Highway Cabinet Member Decision Session

Thursday 9 May 2013 at 1.30 pm

Report of:	Simon Green Executive Director, Place
Date:	9 th May 2013
Subject:	New junction design and Highway Improvements associated with a new Sainsbury's superstore – Wadsley Bridge
Author of Report:	Steve Robinson, Head of Highways Maintenance Client

Report of:	Simon Green Executive Director, Place
Date:	9 th May 2013
Subject:	Highway Improvements associated with a new retail development off Manchester Road/Hunshelf Road - Stocksbridge
Author of Report:	Steve Robinson, Head of Highways Maintenance Client

9.1 Approve the highway improvement works shown on drawing number VD12024-D111 revB.

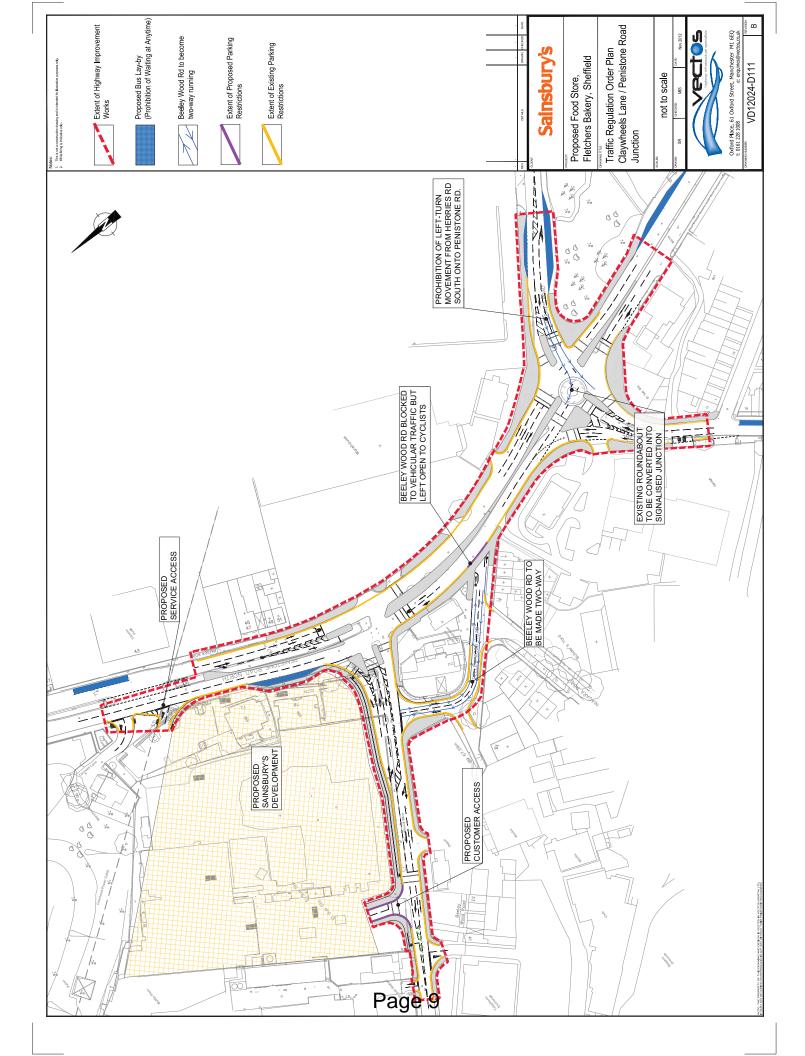
- Query Access to Clay Wheels Lane for 27 metre HGV. Resident - Niagra Forge Response – Standard HGV can access Clay Wheels Lane junction. A 27m abnormal load cannot. However, a 27m abnormal cannot access CWL through the existing situation through Beeley Wood Rd. Clarification is required on this. The signal poles located in the Clay Wheels Lane refuge islands will be fitted with demountable signal poles to allow abnormal vehicles to use this route to access the industrial park to the west.

- Query Access to driveways on Beeley Wood Rd to be maintained Resident - no1 Beeley Wood Rd Response – Access to all driveways on Beeley Wood to be maintained following highway improvement works. Alterations to one-way system and road marking to be altered.

- Query Access to Carphone Warehouse Car Park to be redesigned Resident - Carphone Warehouse Response – Noted. SCC to liaise with Carephone Warehouse to agree access/egress arrangements. Vectos to assist in design where possible.

- Query Parking on the carriageway a problem during construction Resident - no8 Niagra Rd Response – Full traffic management proposals to be agreed with SCC prior to Contractor commencing on site. No construction traffic or otherwise will be allowed to park on the carriageway and restrict vehicular movements in the vicinity.

- Query Residents turning right onto Clay Wheels from 33-41 Beeley Wood Resident – no33 Beeley Wood Response – Possible introduction of 'Keep Clear' or yellow box to enable vehicles from Beeley Wood to egress onto CWL during peak times.

- Query HGV movements being restricted at Leppings Lane and Clay Wheels Lane Resident – Norfolk Estate (Letter 8th Jan 2013) Response – All movements at each junction have been subject to swept path analysis using a 16.4m articulated HGV. All manoeuvres are shown to works comfortably using this vehicle.

- Query Right hand turn into Leppings Lane from Penistone Rd South Resident – (Unknown) Response – Traffic flows have been modelled and show this movement is possible, even during peak times. The signal timings will be optimised to ensure that all significant movements are given enough green time. A filter arrow will be included at this location so right turning vehicles will be able to get onto Leppings Lane without waiting for gaps in opposing traffic.

a. Sequencing of lights not shown – Junction modelling discussed and currently being agreed with SCC.

b. Banning left turn on Herriers Rd South concern for Wardsned Rd – Vehicles are able to access Penistone Rod by travelling east up Herriers Rd and then right down Herriers Rd South.

c. Queuing from Herriers Rd causing traffic to back up to Clay Wheels Ln Modelling shows that this will not be the case. The introduction of the traffic signals is to control the flow of traffic and optimise the operation of the 2 junctions.

d. Request for signalised junction between Herriers Rd South and Herriers Rd

e. Congestion caused by prohibition of left turn on Herriers Rd Vehicles are able to access Penistone Rod by travelling east up Herriers Rd and then right down Herriers Rd South.

f. Congestion caused during school pick up time with parents visiting SSL prior to pick up – travel times along Penistone Rd have actually been reduced by the introduction of the highway works.

g. Consideration given to vehicle movements on match days. – possible match day signal programme can be incorporated?

- Query Consideration for HGV's and abnormal loads turning left into Clay Wheels Lane Resident – William Hague, Hague Plant Hire, Claywheels Lane Response – Standard HGV can access Clay Wheels Lane junction. A 27m abnormal load cannot. However, a 27m abnormal cannot access CWL through the existing situation through Belley Wood Rd. Clarification is required on this.
- Query Beeley Wood Rd currently used as works entrance. Resident – Hillfort Multi Metals, Herriers Rd Response – Works entrance can be accessed from CWL once the new junction is in place. A HGV can access Beeley Wood Rd from Clay Wheels Lane.
- 11. Query -

a. Ahead/right movement from Leppings Lane too wide at 5.5m – This can be reviewed at detailed design stage but hatching can be applied to stop this developing into two lanes.

b. Central reservation on north side of junc encroaches into carriageway – To be reviewed at DD stage but it was locally widened to fit on signal heads.

c. Right turning vehicles into Clay Wheels Lane may go into CWL egress by mistake – correct bollards to placed on CWL egress. However this island can now be lengthened now that ped crossing has been removed.

d. No ped facilities on Penistone Rd north of CWL junction – This has been discussed at some length and the ped facilities have been moved to the south side. This is seen to be sufficient given the likely pedestrian movements.

e. Radius tightened on Carwell Ln – radius has been designed with HGV's in mind and this movement can be made comfortably.

There were concerns expressed by this company, that the new signalised junction at Clay Wheels Lane could have a detrimental impact on access to their site as some of the turning manoeuvres that can presently take place would be removed by the improvement scheme.

A number of alternative suggestions were discussed as to how this issue could be resolved, and it has now been agreed that the proposed junction layout will be amended to allow the right turn from Penistone Road into the site to take place, and there existing access point opposite Clay Wheels Lane will also be signalised to allow vehicles to turn right, with appropriate vehicle detection incorporated to ensure this additional phase within the signals is only called when vehicles are waiting.

9,1 Approve the highway improvement works shown on drawing number W50498/100/36.

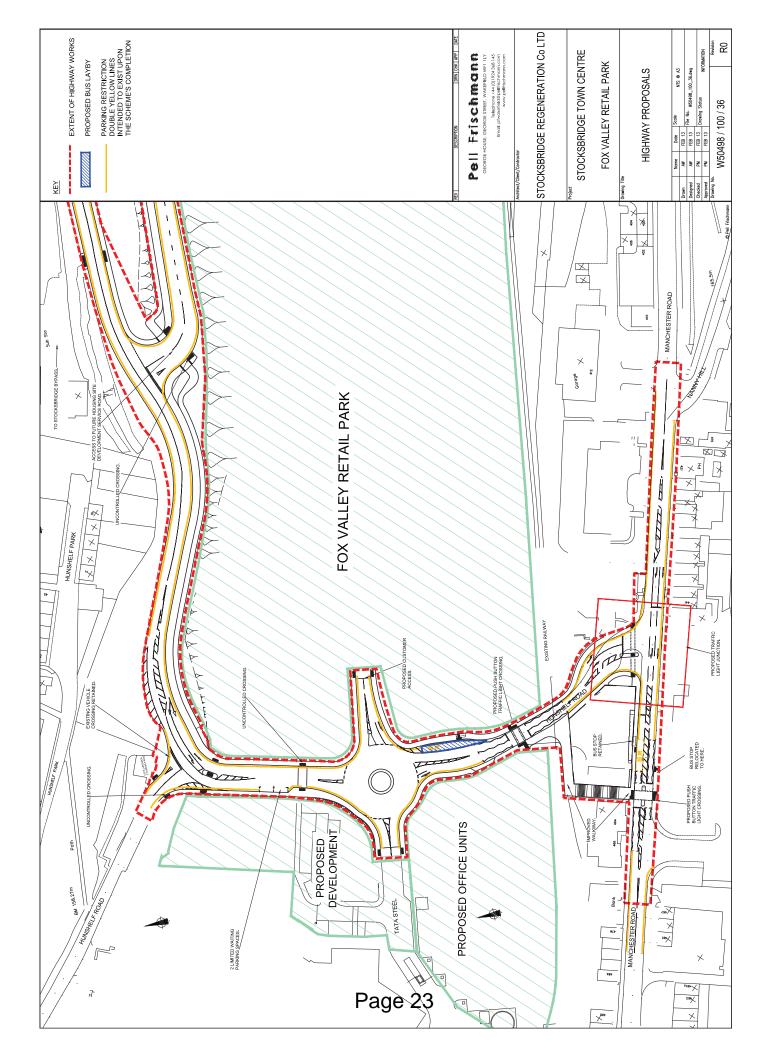
1. The road from the Hunshelf Road leading up to the bypass is for public as well as delivery vehicles but only delivery vehicles referred to in the questionnaire. Can we have notification when this road can be accessible. Disagree with retaining bus stop and provision of new one directly opposite on Manchester Road.

2. Nothing on the form asks about the junction in front of The Works Lunchbox. Has the volume of traffic been underestimated. There is no official PROW stated on the drawings

3. The bridle way stops in the middle of no-where. Concern about traffic queues on Manchester Road

4. Residents of Hunshelf Park would like to see their road upgraded as part of the development

5. Is it a good idea to have bus stops opposite each other with a push button crossing?

6. It is unclear how cycle ways link once the (light blue solid) route is removed

There are already 3 pedestrian crossings in close proximity to each other along Manchester Road, these proposals will add one further set on new signals on Manchester Road and a further new set of signals on Hunshelf Road. Will all these signals cause additional delays/congestion through the town centre.

2. The existing junction on Hunshelf Road outside the "lunchbox" will see a large increase in traffic, will the junction operate without congestion and will there be pedestrian safety issues.

4. Are the new/diverted footpath routes to be public.

5. The position of the pedestrian controlled crossing on Manchester Road directly adjacent to the walkway. Pedestrians especially children emerging from between the two buildings on the walkway may continue straight onto the crossing headless of traffic. This crossing also appears to be very close to the proposed traffic light junction with Hunshelf Road. This could result in vehicles blocking the crossing whilst waiting at the traffic light junction causing a danger to pedestrians.

6. The positioning of opposing bus stops and within the confines of a pedestrian controlled crossing. Should two buses be at the stops at the same time, this could result in traffic delays on a very busy main route. This could also lead to vehicles overtaking a waiting bus within the approach confines of the crossing, resulting in conflict between vehicles and pedestrians using the crossing.

7. The proposed uncontrolled crossing close to the junction of Hunshelf Road and Ford Lane. This crossing very close to a blind bend on a downhill section of the road. This could result in conflict between vehicles and pedestrians.

8. There does not appear to be any traffic calming features to slow vehicles down when exiting the Stocksbridge Bypass, especially on approach to the uncontrolled crossings, especially as this road will probably become a rat run for the people travelling between Manchester Road and the Stocksbridge Bypass

The provision of double yellow lines outside the church will restrict access especially for the disabled to the church on a daily basis and for Funerals and weddings.

10. <u>Have the traffic implications of these proposals been properly</u> considered, are the roads designed to an appropriate standard and will they work satisfactorily when complete, also concerned about access and parking needed for the "Lunchbox"

The road leading up to the Bypass will be available as a public highway for all road users upon completion of the development. We are currently looking at re-location of the westbound bus stop such that it will not be directly opposite the eastbound bus stop.

The scheme has been developed in accordance with an approved Transport Assessment and adequately deals with the predicted volumes of traffic. All PROW will become official routes once the necessary Stopping Up Orders are in force upon completion of the scheme.

The Bridleway will continue through to Manchester Road as part of the proposed housing development to the east of the retail park. The scheme has been developed in accordance with an approved Transport Assessment and adequately deals with the predicted volumes of traffic.

There is no proposed development traffic along Hunshelf Park and as such this road does no merit any improvements under the S278 Agreement with the developer.

We are currently looking at re-location of the westbound bus stop such that it will not be directly opposite the eastbound bus stop.

The cycleway will be provided alongside the existing road within the proposed housing development for part of its length where it will then travel around the perimeter of the housing development to meet up with the existing routes.

The existing crossing outside the Town Hall will be removed. A new crossing will be provided by the Britannia Building Society. An existing zebra crossing will be retained to the west, by the precinct. Operation of the new signal controlled junction with Hunshelf Road has been simulated using computer software and found to perform satisfactorily when subjected to the development traffic, combined with a significant amount of traffic transferring to the through movement up to the A616. Pedestrian crossings will only stop traffic on demand, by a pedestrian. The timings/phasing of the signals will optimize the smooth passage of traffic as best they can. The option of transferring to this new route to the A616 offers the potential for less traffic passing through Vaughton Hill, freeing up congestion along the valley bottom through Deepcar

Hunshelf Road currently accommodates two-way traffic, which will continue to be the case. The proposed junction arrangement by the Lunchbox is considered a safe one, and has passed an independent Stage 2 Road Safety Audit. Once the scheme has been constructed, a further Stage 3 Road Safety Audit will be undertaken. If additional safety features are deemed appropriate, they'll be added to the scheme. The provision of a pedestrian refuge in this location should hopefully assist pedestrian crossing movements. 3. The junction of the link road with the service access (and future residential access) this will be a busy junction that may not be big enough to accommodate right turning vehicle.

Swept-path analysis has been undertaken for all turning maneuvers, which can be undertaken simultaneously without collision

The cycleways & footpaths will be public and in some instances adopted.

The gradient of the walkway and steps should prevent young children getting too far ahead. If when we undertake the RSA3, this is a problem, we can look to add some chicane type pedestrian rails/barriers at the top of the walkway. In terms of traffic blocking back, the sequencing of the signals should prevent this.

The bus stop within the confines of the crossing will be moved to the west.

The existing boundary wall will be demolished, opening up the junction. You'll be able to see across the land to the rear of units A & F, as it slopes away from the rear of the bridleway. A sight line in the order of 85 metres is achievable. Vehicles will be travelling slowly round the bend. The pedestrian refuge and bollards will also help to highlight the likelihood of pedestrians crossing in this location.

Where the road leading to the by-pass isn't lit, 30 mph roundels will be provided. If it's evident that speeding is a problem approaching the abovementioned pedestrian refuge, this will be addressed within the RSA3, with the provision of signs/lines/coloured surfacing.

The TRO proposals have yet to be advertised. If we can reduce the amount of double yellows we will. However, provided a road safety issue isn't being created, some loading and parking is permitted from double yellow lines.

Some short-stay on-street parking (15 mins) will be provided on-street just above the roundabout for customers of The Lunch Box, who can also use the car park within the development. With regard concerns relating to volume of traffic and highway geometry, these have been considered within the Traffic Impact Assessment submitted with the planning application. The junctions perform satisfactorily when subjected to the development traffic, and even with 50% drive through traffic traveling to the A616. The highway geometry complies with national design standards.
